Change Notice

PCN No: 129

Notice Type: Product Revision Change

Product Type: SL164

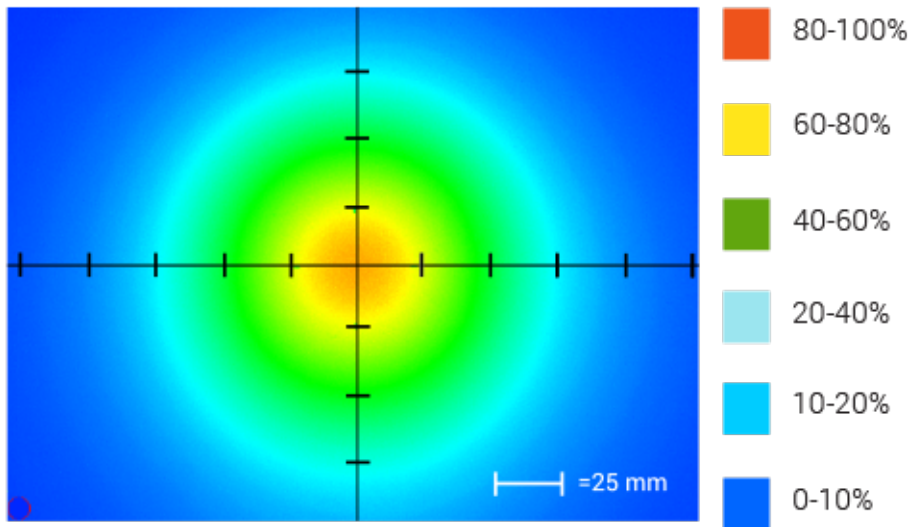
In an effort to improve our products, Advanced illumination (Ai) will update the LEDs used in the SL164 design. This change will result in a brighter, more uniform light at the same price*. Customers may still buy the current revision of this model until July 15th of 2016. After that time, orders for these products will be converted to their respective SL164 Revision A models.

This LED change will result in additional wavelengths being available: 365nm, 375nm, 385nm, 395nm, 405nm, 455nm, 470nm, 505nm, 530nm, 590nm, 625nm, 660nm, 730nm, 850nm and 940nm. Additionally the white LED color temperature will be changing from 6100K to 5500K.

*UV wavelengths (365nm, 375nm, 385nm, 395nm & 405nm) will be sold a higher list price, which will be released at the time of product introduction.
